VALLEY VIEW SUBDIVISION

PREVIOUSLY KNOWN AS BINZ ENGLEMAN SUBDIVISION
MASTER DEVELOPMENT PLAN

Re: Valley View Subdivision (Amendment) MDP # 789-B

The City Staff Development Review Committee has reviewed Valley View Subdivision Master Development Plan (M.D.P.) # 789-B (Amendment). Please find enclosed a signed copy for your files. Your plan was accepted however please note the following:

70' TYPICAL STREET SECTION
SCALE: HORZ. 1" = 10'
VERT. 1" = 5'

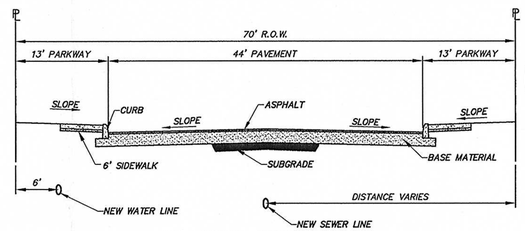
2. Construction of an internal collector street system approximately 1400-feet in length. Collector street design parameters consist of 70 feet of ROW and 44 feet of pavement (Table 506-3). The proposed collector street shall have no houses fronting (UDC 35-515, (c)(4)).

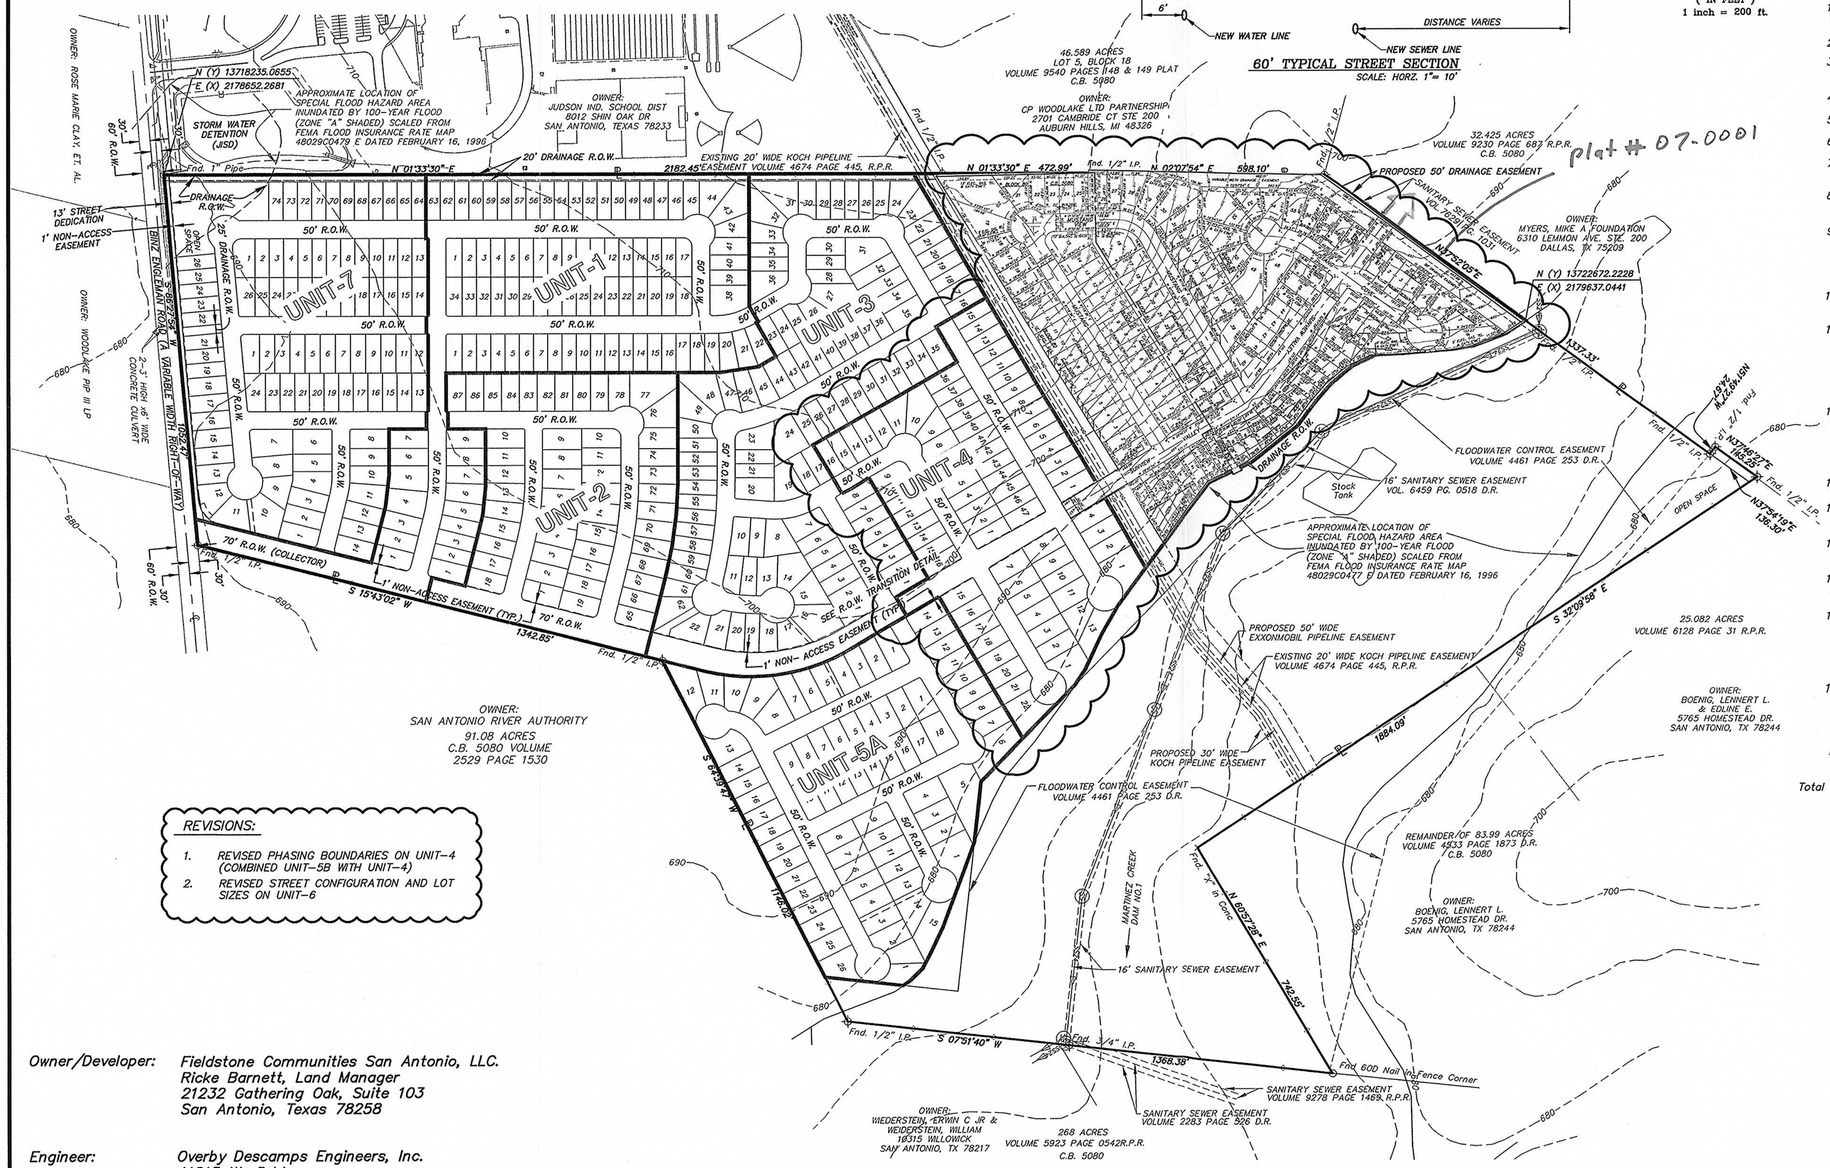
- **Development Services** as part of the conditional approval, cite at the time of platting Unit-6 shall satisfy this section of the City of San Antonio Unified Development Code (UDC) by the following means:

1. Provide and construct the street stub-out and drainage culvert in accordance with the UDC or
    2. A variance request to section 35-506, (e) Connectivity, (2) Projecting Streets before the Planning Commission

- **Storm Water Engineering** as part of their conditional approval cite the following:
  1. Please note that according to Walzem Farms Subdivision drainage study, June 2002, the 100yr ultimate development causes the Martinez Dam Site#1 pool level to rise to an elevation of 676.38. All structures adjacent to the inundated area must be at level two (2) feet above this water surface elevation. The crest of Martinez Dam Site#1 is at an elevation of 680.6 feet.

2. In case a storm event of a higher magnitude hits this general area, the floodplain inundation may cause major flooding in the adjacent areas of the dam. The hydraulic inadequacy of the dam makes it unable to pass the Probable Maximum Flood (PMF). The proposed development will be inundated up to the elevation when the breach occurs and will be above the crest of the dam. Even floods of lesser magnitude, assuming routing starts at the emergency spillway, will also flood the proposed development. The consultant must determine this elevation and routing of the PMF is needed. The engineer

1. Binz-Engleman Road- The Developer shall dedicate 43 feet of ROW (Ordinance 98282, October 2, 2003 Major Thoroughfare Plan (MTP)) from the centerline of Binz-Englemen Road (Secondary Arterial Type A – Uniform Development Code (UDC) 35-506, (g), (2) adjacent to this proposed project. The total length of property frontage is 1052.47- feet as indicated by submitted MDP.

3. Construction of an internal Local B Street approximately 1200-feet in length from the end of the proposed collector to Unit 6 (UDC Appendix A, Definitions of Local A and Local B).

4. All Roadways shall conform to UDC 35-506(c), (1), Table 506-1: Functional Classification System Description.
  5. The developer shall be responsible for upgrading the intersection of Binz-Engleman Road and the Collector Street. This includes a sufficient left-turn storage lane on eastbound Binz-Englemen Road, with a bay taper and transition (UDC-35-506,(m),(2) and a right-turn deceleration lane (westbound Binz-Engleman Road) with a storage lane and bay taper as it relates to the submitted TIA traffic counts, (UDC –35-502 (a)(7), subsection C.
